SEWAGE DISPOSAL SYSTEM

HOWARD COUNTY HEALTH DEPARTMENT

REPAIR - PURPOSE - IN SUPPORT OF BUILDING PERMIT No. 59614 INCREASED IN NUMBER OF BEDROOMS IN ADDITION.

RE: Mr. and Mrs. William Schwarz
1900 Woodstock Road
Serial Number: 59614
Proposed Use: Addition

P 39250

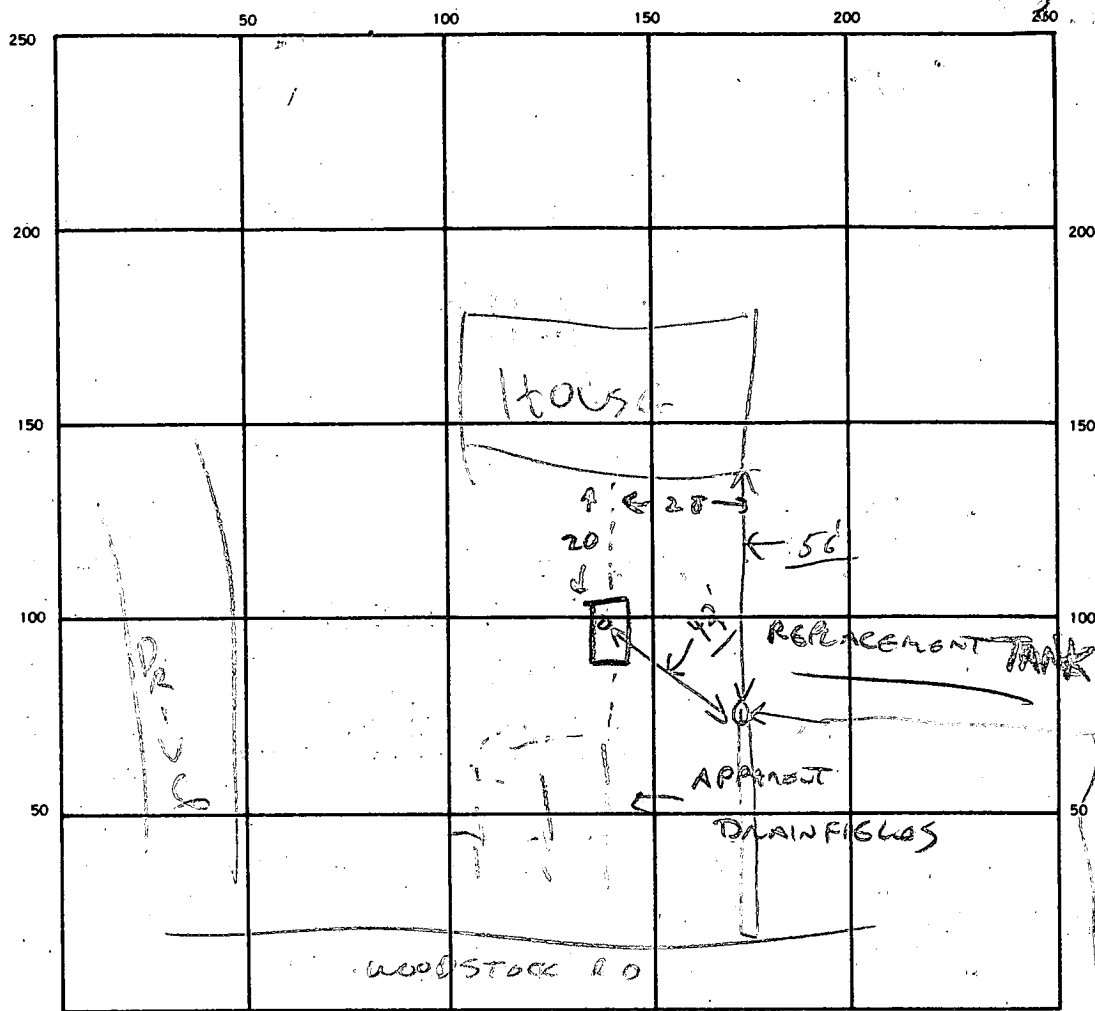
REMARKS REPLACED COLLAPSED METAL TANK WITH 1000 G. CONCRETE,
PVC PIPING JOINED TO EXISTING TERRA COTTA,
THE FIELDS APPEAR FUNCTIONAL 5/11/87 CH
